PROJECT	Cornamaddy Noise Amendment	
SUBJECT	Inward Noise Impact Assessment	
DOCUMENT REFERENCE	267501.0682NT01	
DATE	9 July 2026	
WRITTEN BY		APPROVED BY
Alistair Maclaurin		Stephen Smyth
Senior Acoustic Consultant		Director (Operations)

This report presents an update to the Inward Noise Impact Assessment that was submitted as part of the Ballykeeran Gardens planning application under planning reference 2360074. Following an update to the layout of the Proposed Development, the Inward Noise Impact Assessment has been revised to account for the proposed alterations.

Figure 7 Façades Requiring Acoustic Glazing and Ventilation (highlighted blue)

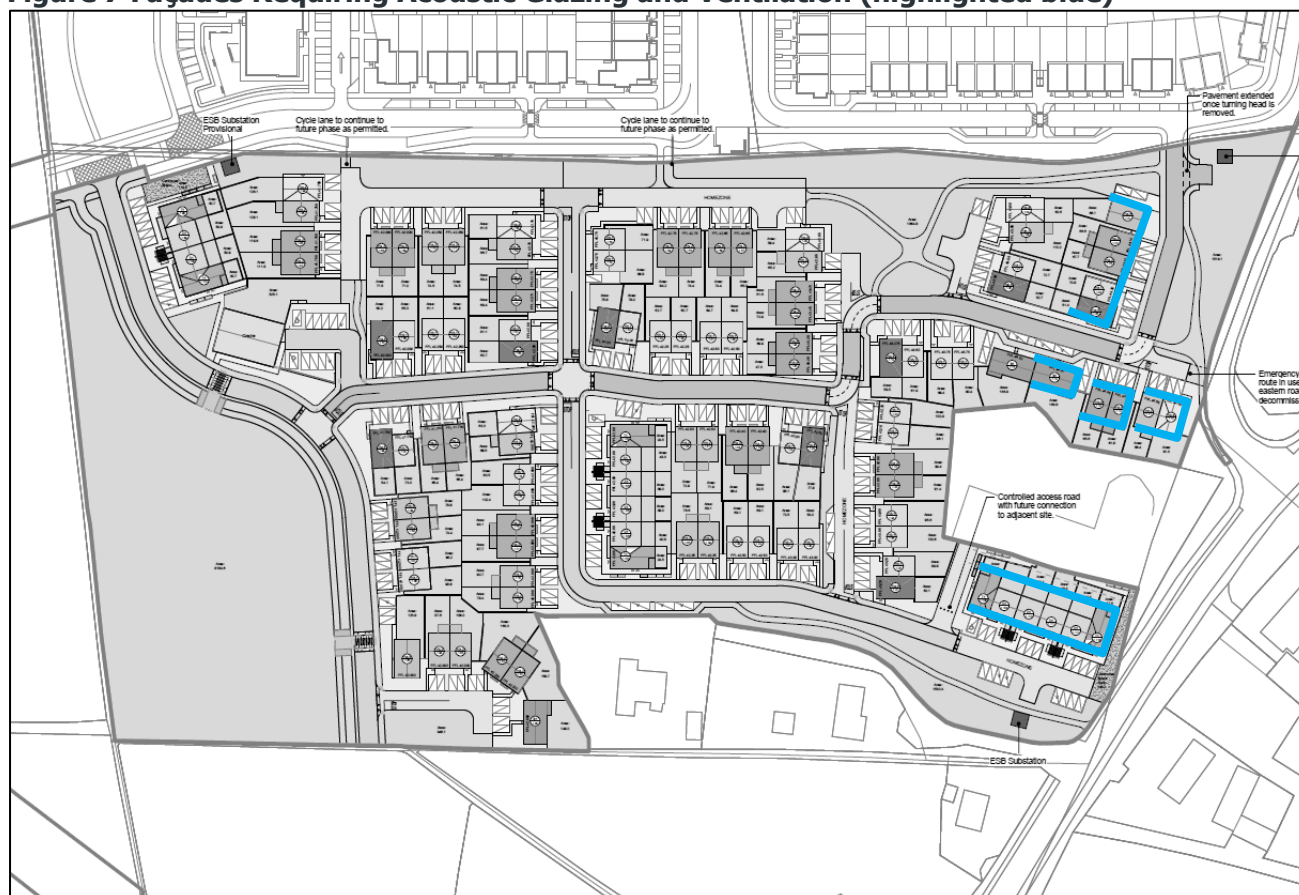
The specifications were accompanied by Figure 7 in the original report, which identified the façades where upgraded sound insulation was proposed.

Following a review of the updated layout for the Proposed Development, it has been confirmed that no changes are required to the glazing and ventilation specifications presented within the original report. However, Figure 7 has been updated to reflect the revised layout and to identify the façades that require upgraded sound insulation. Any façades that are not highlighted in Figure 7 are expected to achieve good internal noise levels with standard glazing and ventilation systems.

The submitted Inward Noise Impact Assessment (document ref. 227501.0443NR01a) identified the glazing and ventilation performance specifications for certain façades, as set out in Table 10 of the original report and reproduced below. These specifications were set out to ensure the internal guideline noise levels are met. A ventilation specification of 34 dB $D_{n,e,w}$ was also specified for the affected façades.

Glazing Specification	Octave Band Centre Frequency (Hz)						Rw
	125	250	500	1k	2k	4k	
Blue	29	25	32	34	36	38	34

The glazing specifications relate to bedrooms and living spaces. For staircases and other non-sensitive spaces, standard double glazing provides a suitable level of sound insulation.
